Re: Indian Point Unit No. 2
Docket No. 50-247

This letter and attachment provide the additional information on NUREG-0737 Item II.B.3 "Post Accident Sampling System" as requested by your letter dated June 30, 1982. This submittal includes a response to each criterion as delineated in your June, 1982 letter and our current interim procedure for assessment of core damage following a postulated accident.

POST ACCIDENT SAMPLING SYSTEM IN RESPONSE
TO LTR DTD 6/30/82

Post Accident Sampling System Response to NRC letter dated June 30, 1982

FIGURE 2
POST ACCIDENT SAMPLING SYSTEM
(PASS)

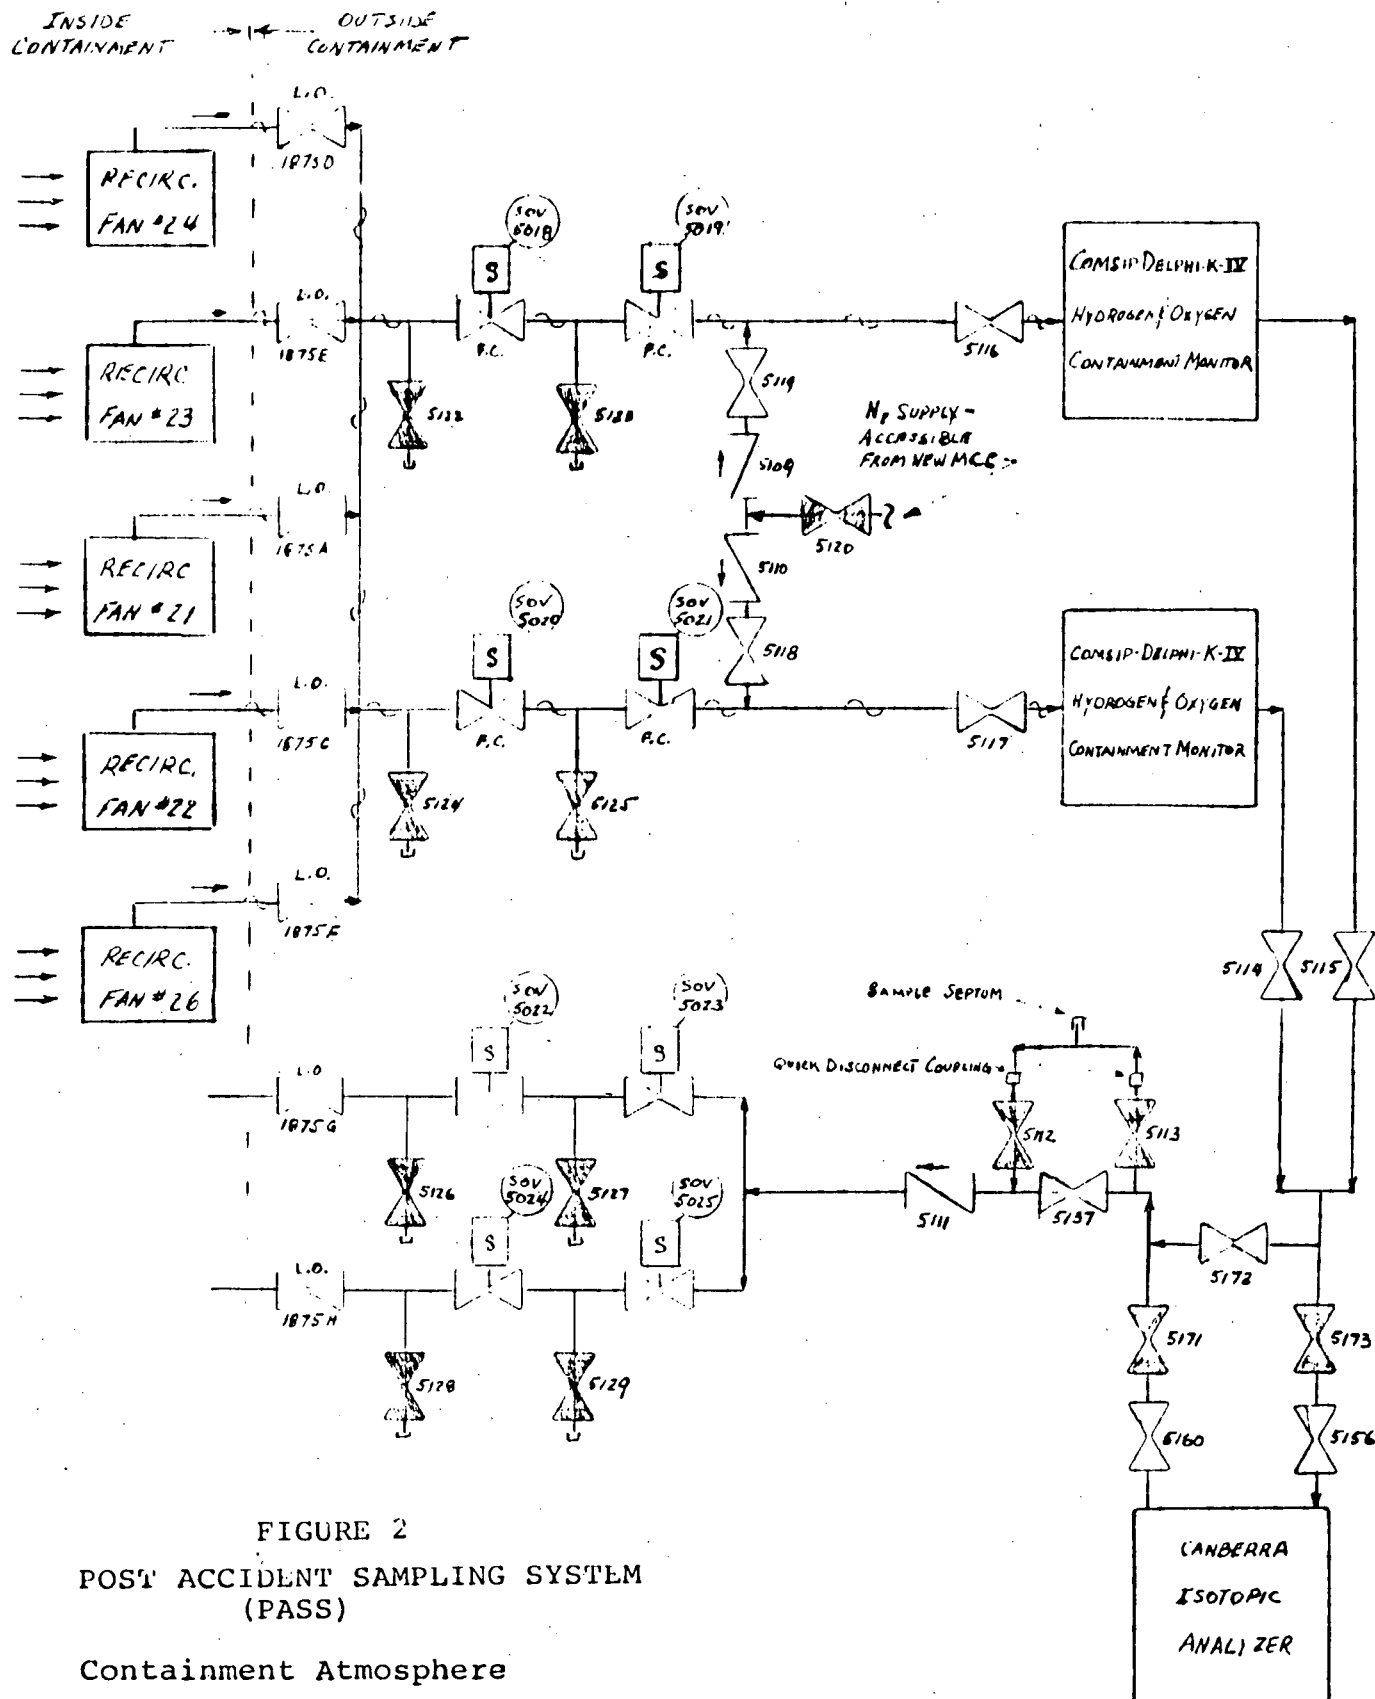
Reactor coolant and containment atmosphere sampling during post accident conditions shall not require an isolated auxiliary system (e.g., the letdown system, reactor water cleanup system (RWCUS) to be placed in operation in order to use the sampling system.

System schematics and discussions should clearly demonstrate that post accident sampling, including recirculation, from each sample source is possible without use of an isolated auxiliary system. It should be verified that valves which are not accessible after an accident are environmentally qualified for the conditions in which they must operate.

Reactor coolant and containment atmosphere sampling and recirculation during post accident conditions are not dependent on the availability of any auxiliary system which may be isolated during accident conditions. The IP2 PASS is shown in the system schematics provided by Figures 1 and 2.

Containment atmosphere samples (Figure 2) are obtained from the five containment recirculation fan discharges through a common manifold and two separate heat traced lines. A sample is drawn into two separate class 1-E Comsip-Delphi Hydrogen and Oxygen Monitors by diaphragm pumps and discharged back to containment.

SOVs 5018, 5019, 5020, 5021, 5022, 5023, 5024 and 5025 are located on a rack, Elev. 67'-6", outside the containment wall, where sample penetrations come through the containment. These SOVs are normally closed with the Comsip-Delphi in the standby position. They are opened remotely when taking a sample by operating switches on the Comsip-Delphi Remote Panels in the MCC room, Elev 98' P.A.B.
